Subject: ADDENDUM NO. 4

Project: TROY UNIVERSITY NATATORIUM DEMOLITION
TROY UNIVERSITY MAIN CAMPUS - TROY, ALABAMA

Job #: SSL# 20121
BC# 2020764

ASBESTOS REMOVAL FROM THE NATATORIUM ADDENDUM 4, GARDNER AND HAMIL HALLS TROY UNIVERSITY, TROY, ALABAMA		JOB NUMBER: MA-4103	SCALE: 1"=20'
		DRAWING NO: 4103-01	DRAWN BY: WHK
		DATE: 3-24-21	CHECKED BY: WHK

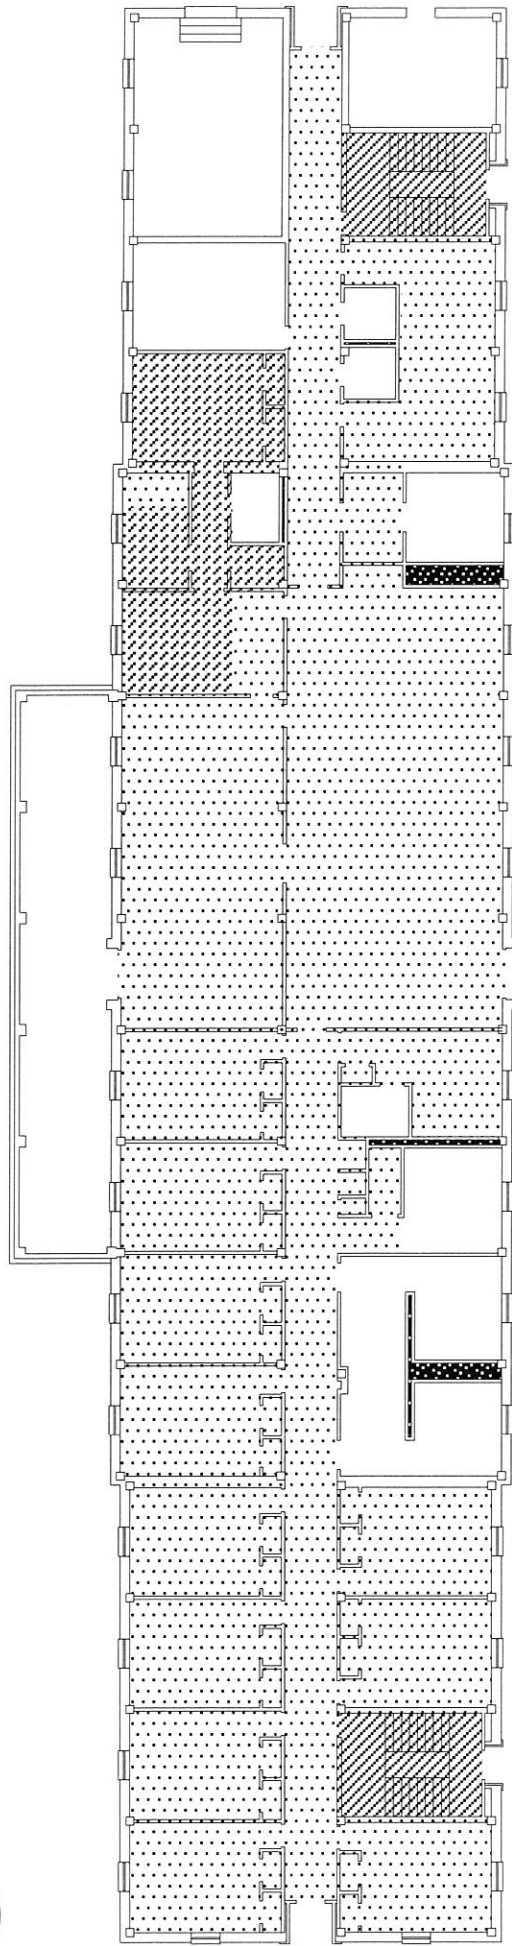
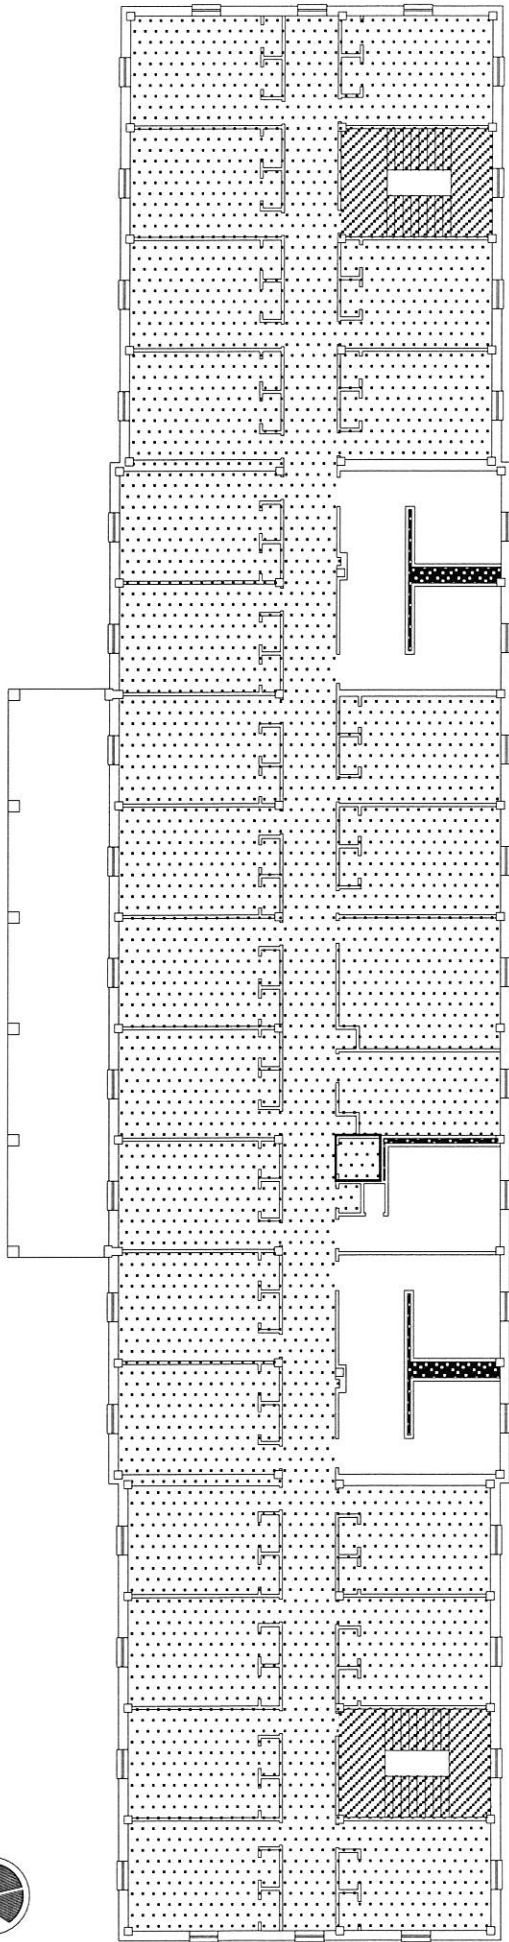
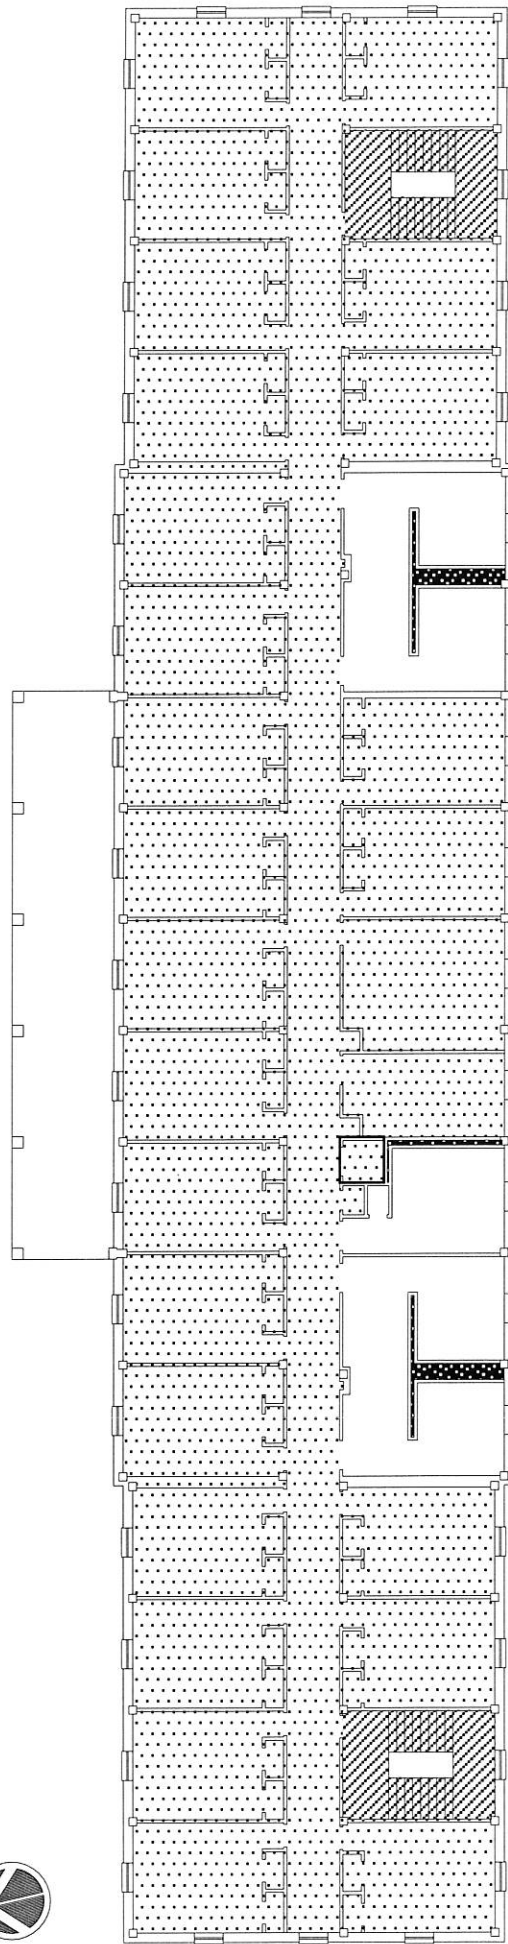
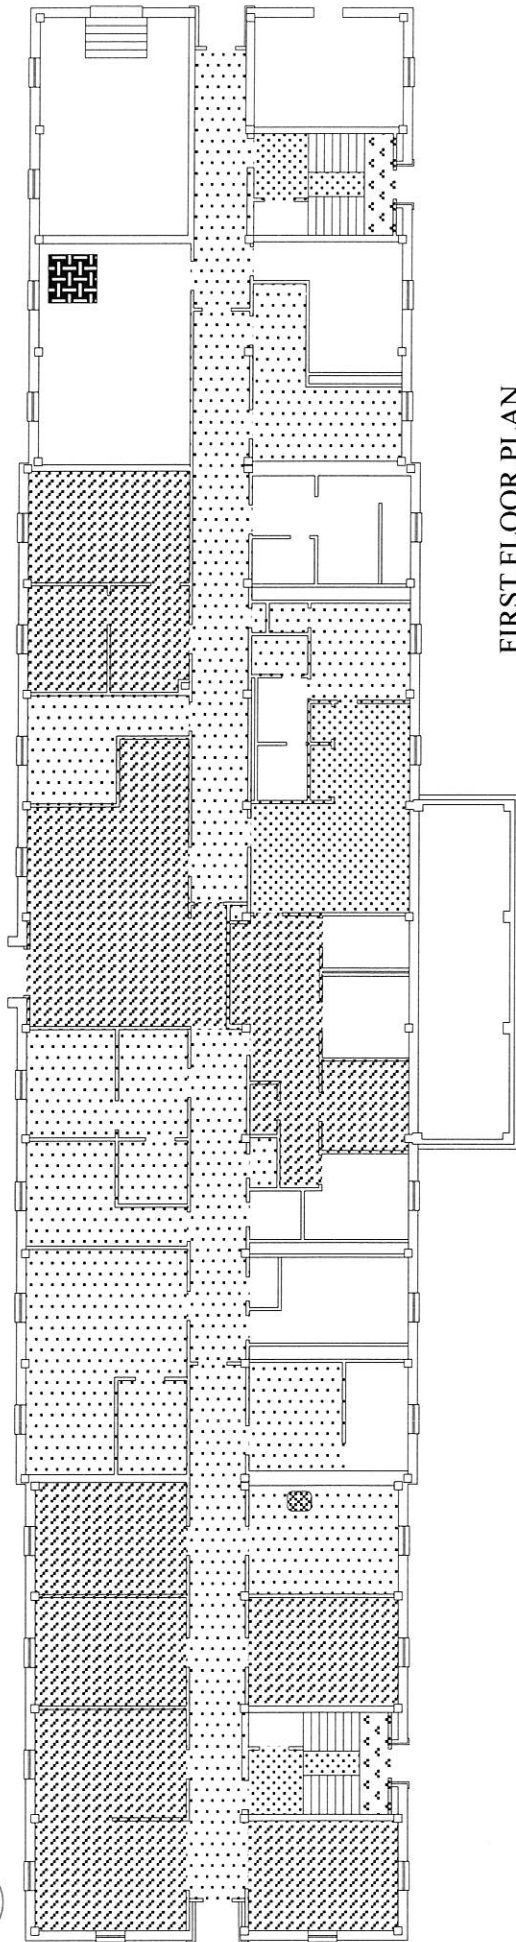
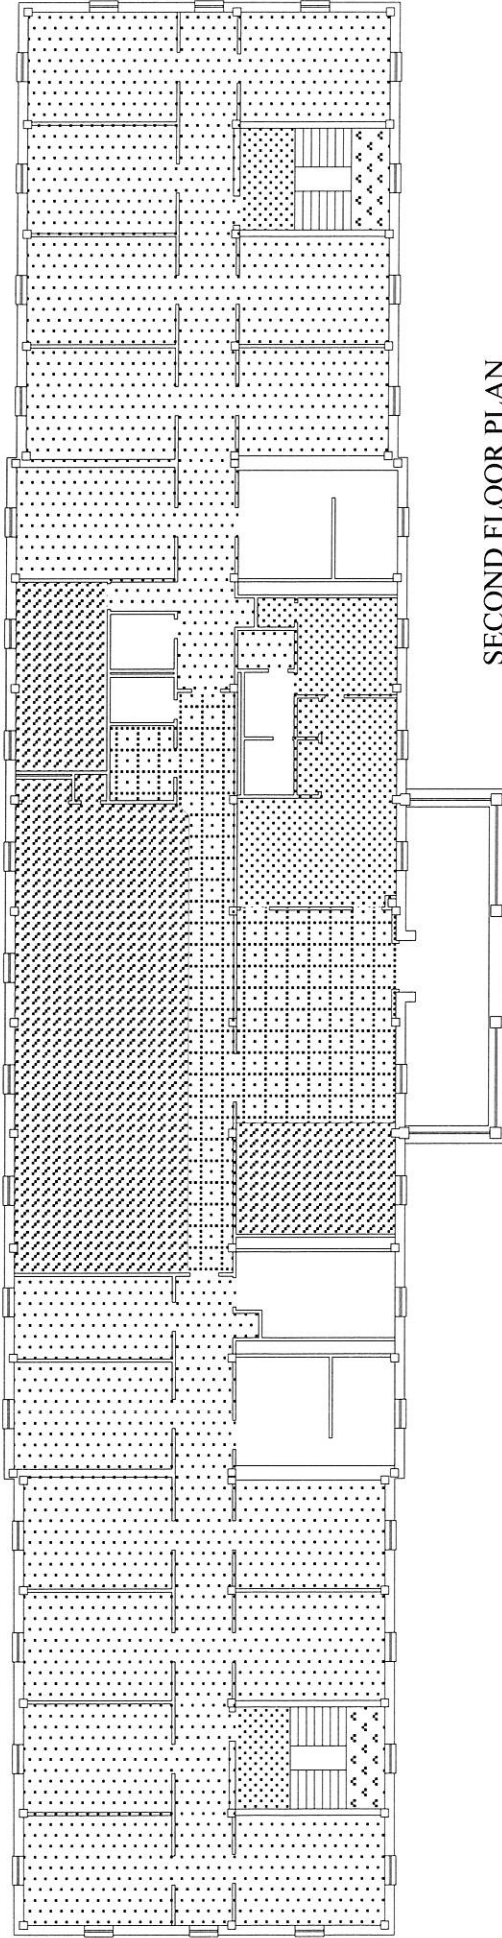
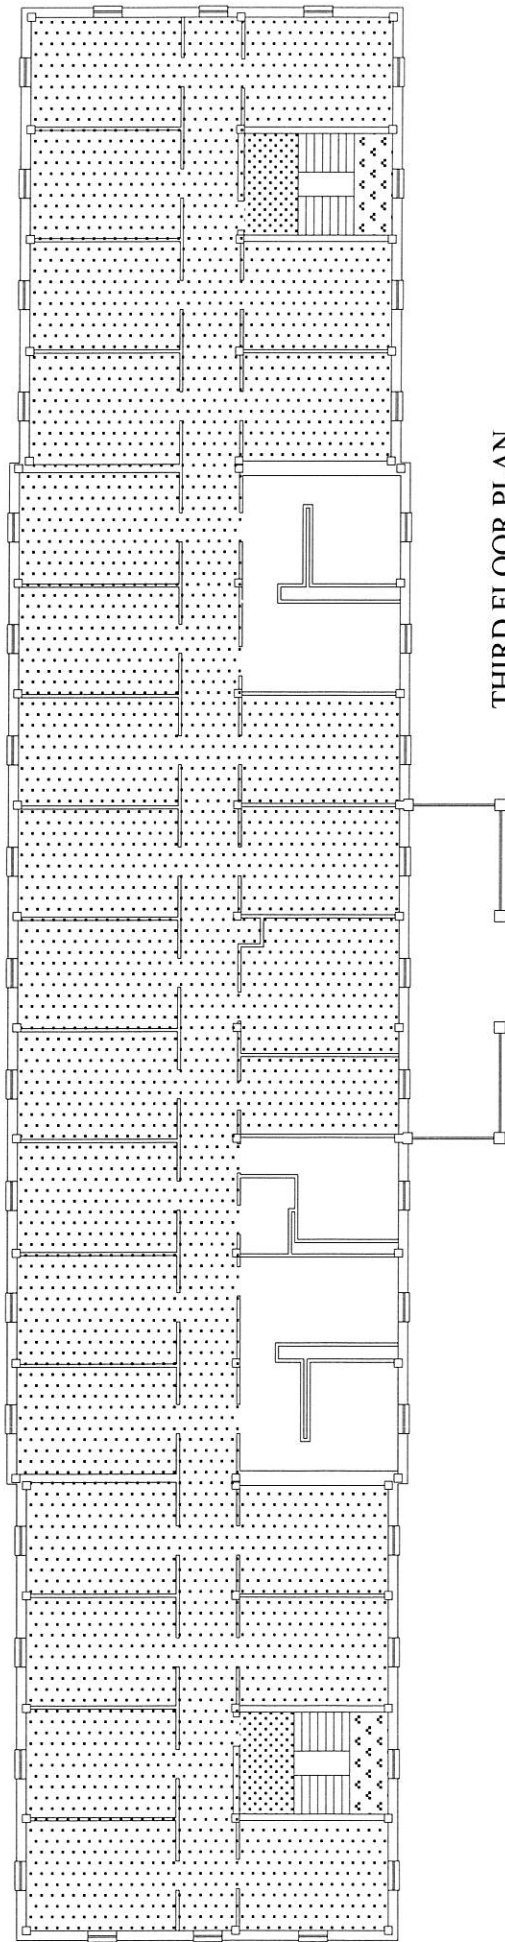
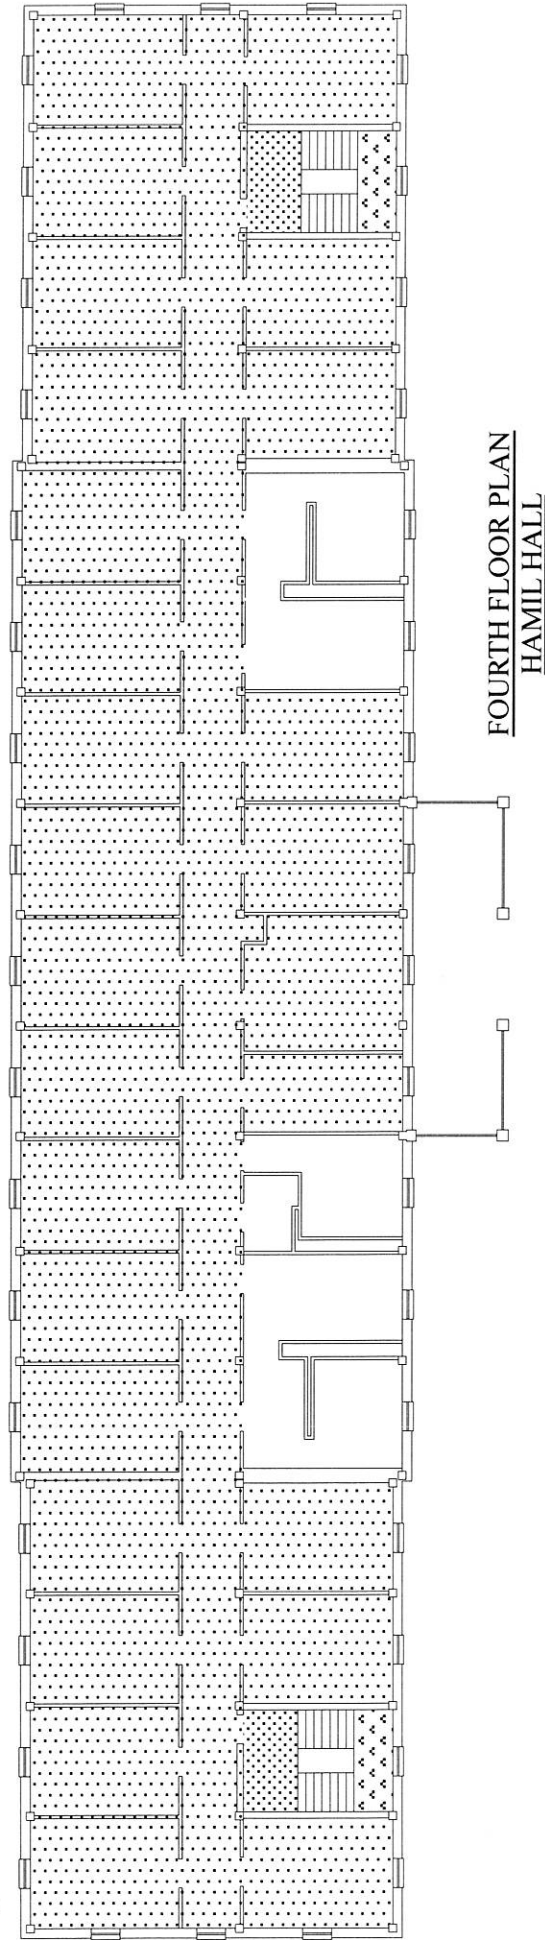
Item 19: Refer to specification Section 02 8200 Asbestos Removal. Add the attached asbestos abatement drawings for Gardner & Hamil Halls behind the asbestos abatement drawings for the Natatorium.

Sheet Title
GARDNER HALL
DEMO PLAN

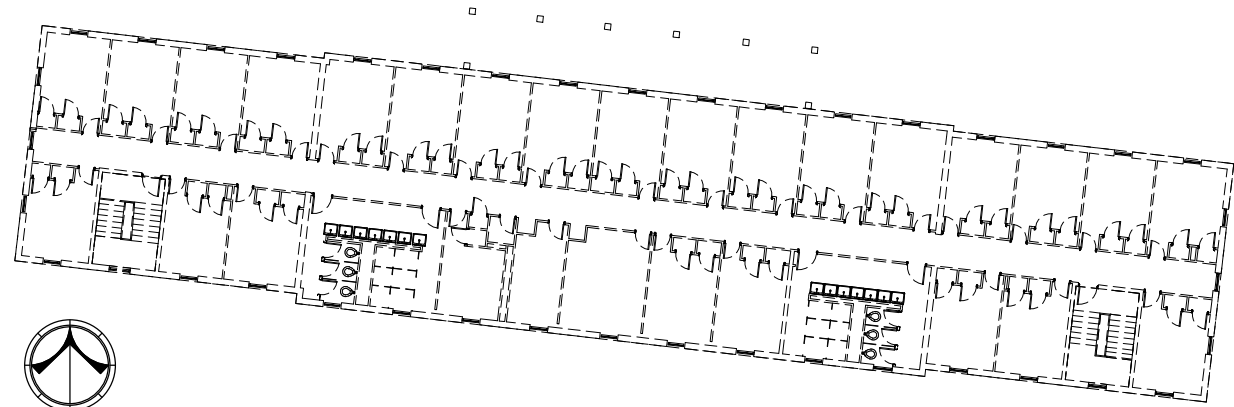
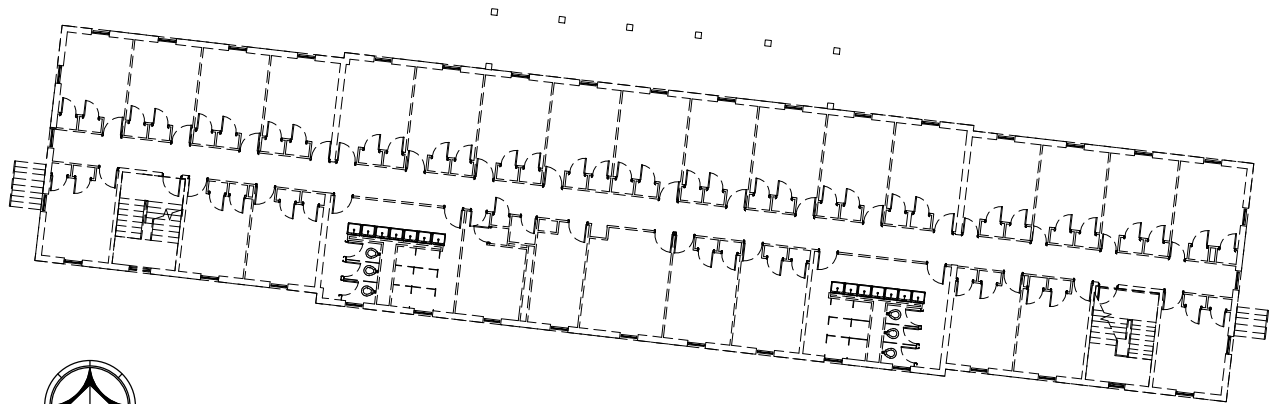
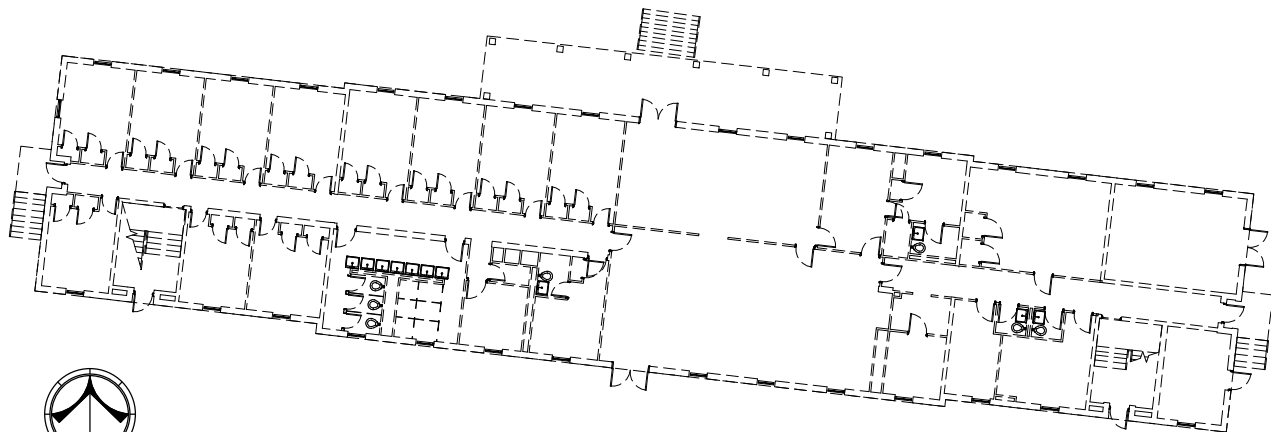
- Item 1:** Refer to Drawings, Sheet A1.2, Gardner Hall Demo Plan. Add the sheet and all drawings identified in clouded areas. Clarification: Demolition of Gardner Hall has been added to scope of project.

Sheet Title
HAMIL HALL
DEMO PLAN

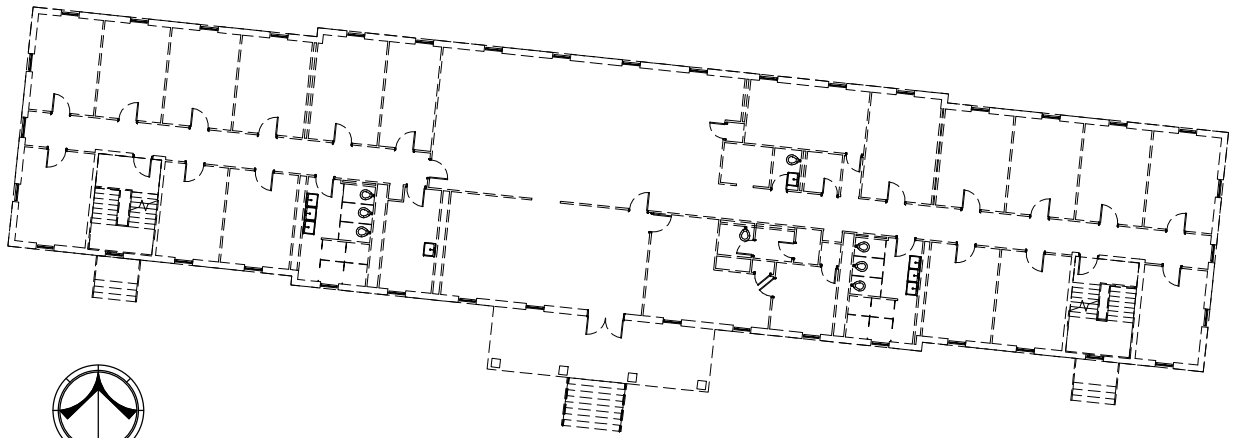
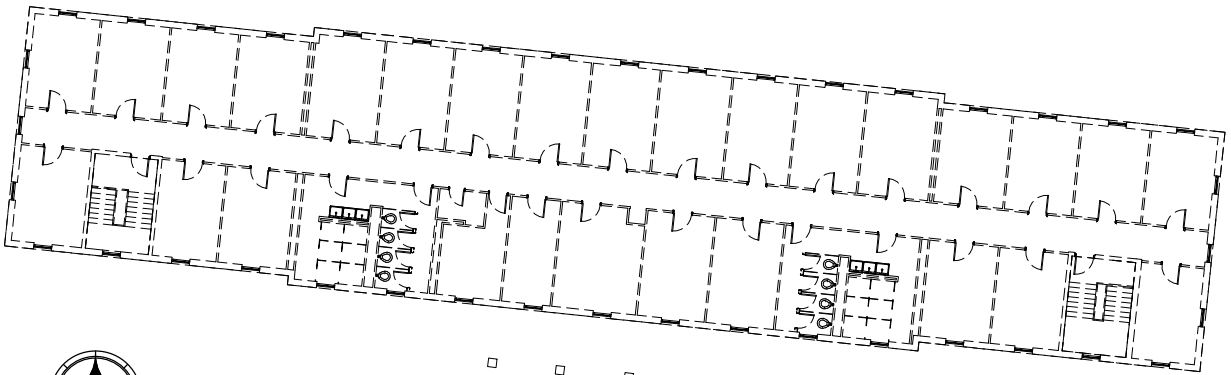
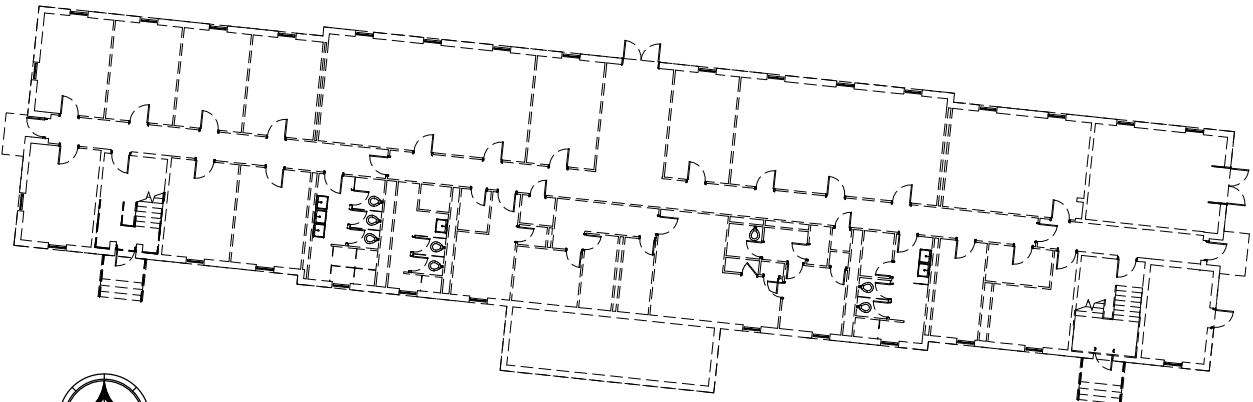
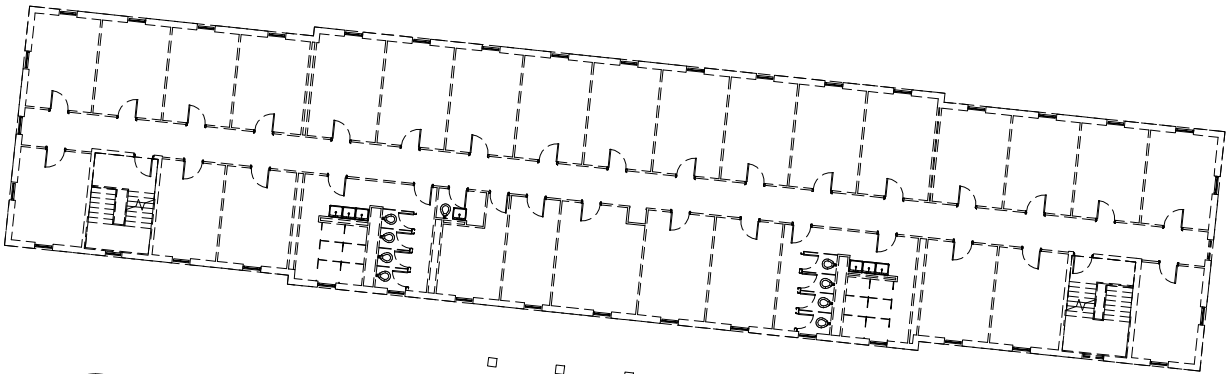
- Item 2:** Refer to Drawings, Sheet A1.3, Hamil Hall Demo Plan. Add the sheet and all drawings identified in clouded areas. Clarification: Demolition of Hamil Hall has been added to scope of project.
